City of Hiawatha
Community Development Department

Purpose:	Preliminary Plat	**Date: 8/28/2018**
To:	Hiawatha City Council	
Name of Plan:	Sherman Square Addition	
Address:	Various:	**Zone**: C-4
Number of Lots:	20 lots	
Reviewed by:	Patrick Parsley, Community Development Director

Re: **Sherman Square Addition**

Description: **Revised Preliminary Plat**

PRELIMINARY PLAT
SHERMAN SQUARE ADDITION, HIAWATHA, LINN COUNTY, IOWA

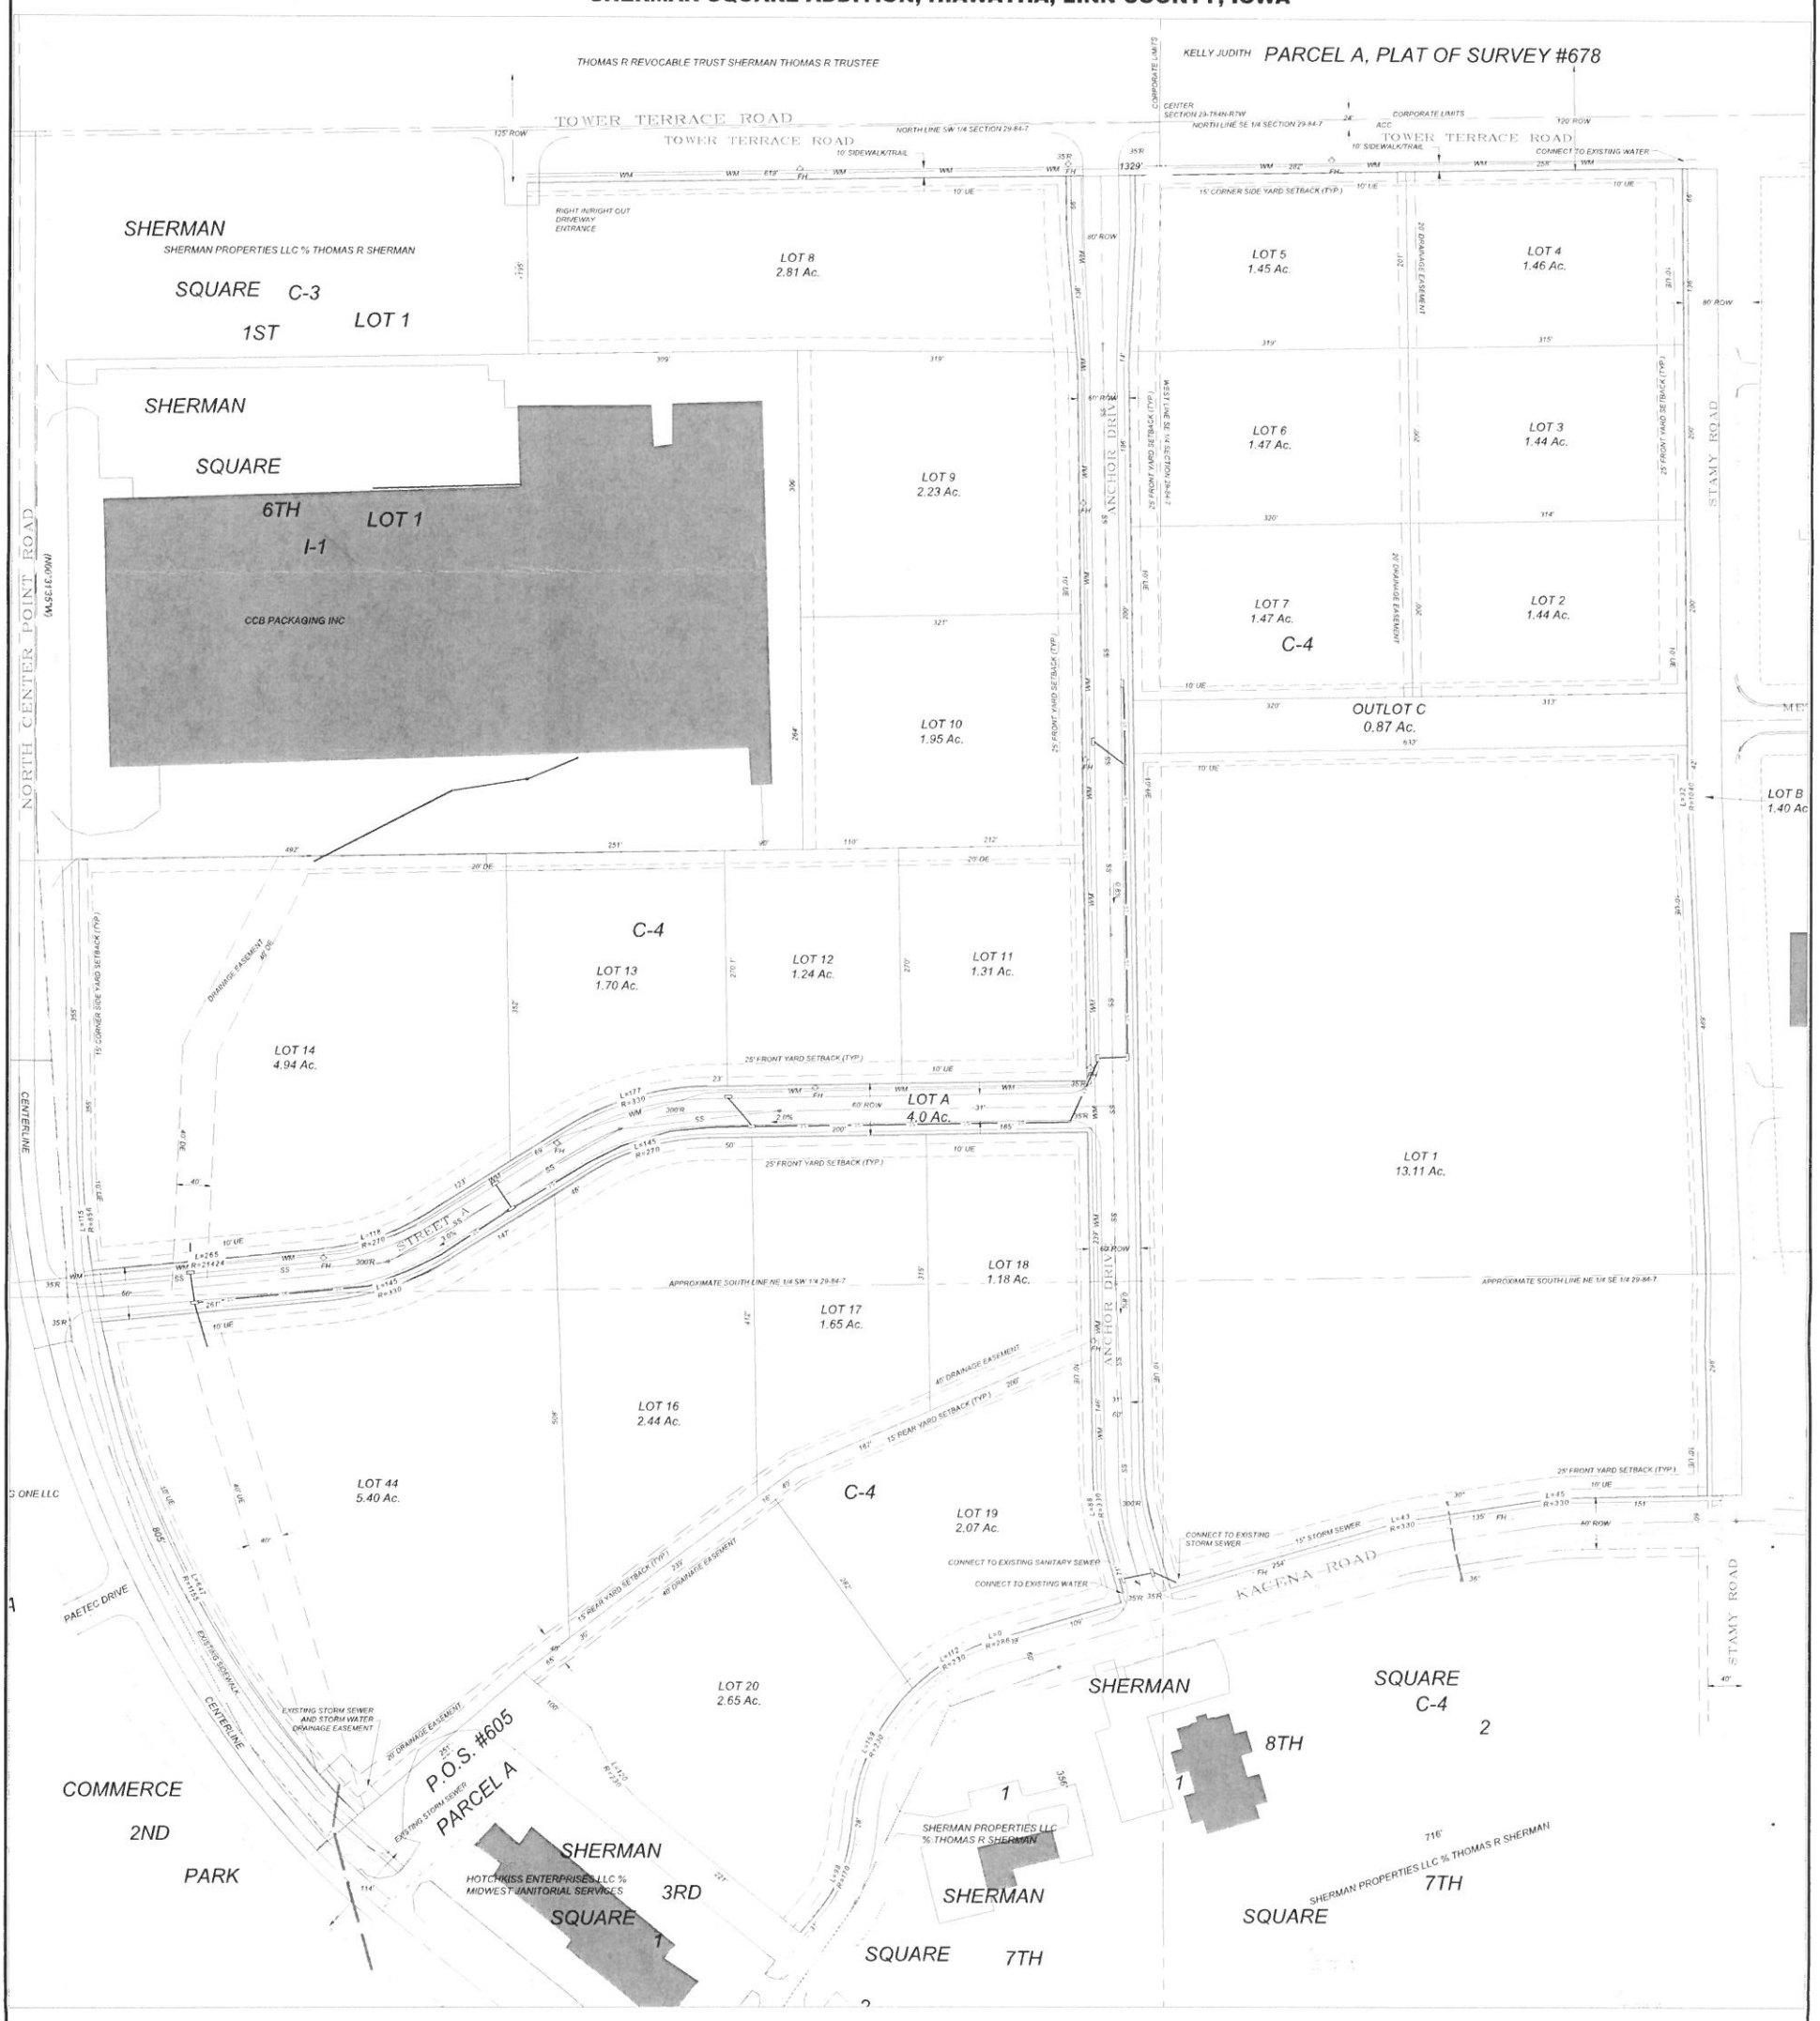
1. The new C-4 setback requirements are noted.
2. A new standard for access spacing on Tower Terrace is now in place. The applicant is aware the Anchor Drive intersection and the driveway entrance west of Anchor Drive may become right-in-right-out with the future design of Tower Terrace Road. No additional access will be permitted on Tower Terrace Road.
3. Access to NCPR has been modified to accommodate possible future development west of NCPR.
4. Sidewalks and trails in accordance with Metro Standards on all streets abutting this development have been detailed.
5. The plat indicates the method for storm water management is per lot.

This is approximately 40 acres east of Center Point Road and south of Tower Terrace Road that had an original preliminary plat approved in the 1990's. The additions of the 1st through the 8th have been previously approved and developed. The 9th addition was just recently approved, but included a proposed street and lot layout that made the old preliminary plat not valid with the current development schedule. For that reason, we requested that the preliminary plat be revised to match the intent of how the area will be developed.

This revised preliminary plat better represents the recent opportunities for growth and how this area would most likely be developed in the future. It provides for an additional access to North Center Point Road and to Tower Terrace Road. However, the access to Tower Terrace may be a right-in and right-out sometime in the future. The proximity to the Stamy Road intersection does not meet our intended access spacing on Tower Terrace Road. As the land develops on the north side of Tower Terrace, opposing access drives might also require the installation of channelizing islands to control traffic conflicts. The developer is aware of the possibility.

The proposed roadway and lot layout is substantially in compliance with the intent of a commercial area. The plan allows for the necessary installation of adequate public utilities and access to serve the future growth.

Hiawatha Water Department has reviewed the proposed plat for Sherman Square Addition. The plan meets the water department requirements for construction. However the Water Department reserves the right to require a field change if deemed necessary.
